Product Change Notice (PCN)

PCN Number: **PCN-0451165R-01**

Product(s) Affected: **PJ-041H**

Description of Change: **Mechanical, electrical, and material changes as shown below:**

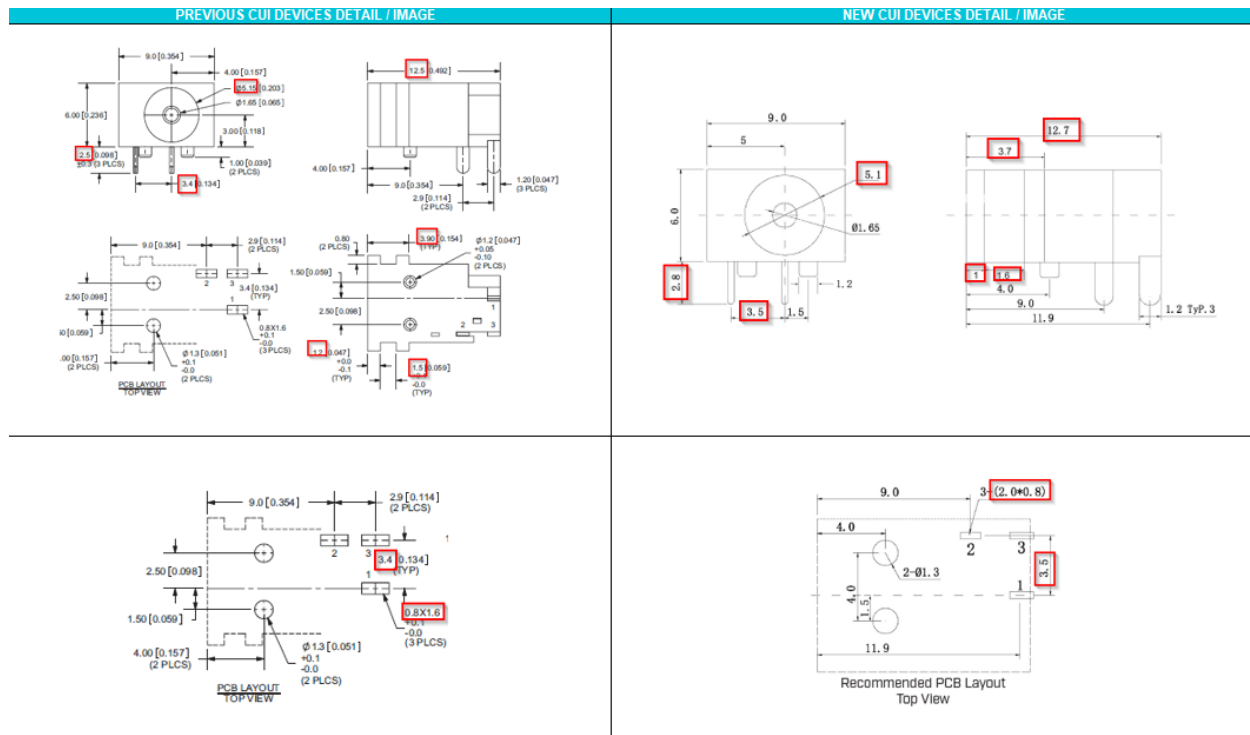
MATERIAL	PLATING
center pin	brass	silver
terminal 1	brass	silver
terminal 2	copper alloy	silver
terminal 3	brass	silver
plastic	PA66

DESCRIPTION	MATERIAL	PLATING/COLOR
center pin	brass	silver
terminal 1	brass	silver
terminal 2	C5191 phosphor bronze t=0.30	silver
terminal 3	C5210 brass t=0.30	silver
housing	PAB6 (LJL94V-0)	black
